Erection of Single Storey Rear Outbuilding

for Highgate Conservation Area Advisory Committee

Waterlogged ground in the allotments behind.

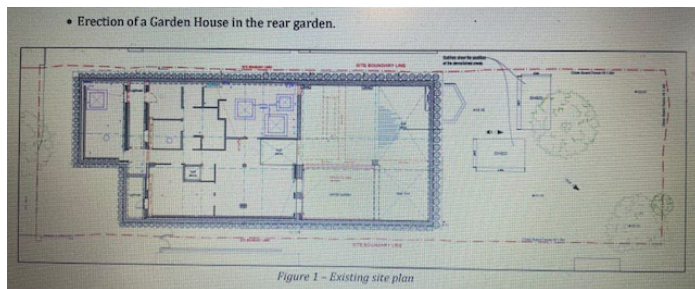
This area is prone to flooding. Adding such a large building to a site where a basement has been allowed and the built footprint has increased so much, would only increase the danger of flooding. The Allotments to the rear are designated Local Green Space and the rear garden was part of the Ecological corridor linking those allotments with Hampstead Heath. HNP Appendix 3. The landscaping should refer to the Local Green Space and enhance the local habitat, ecology and environment. This proposal does none of those things
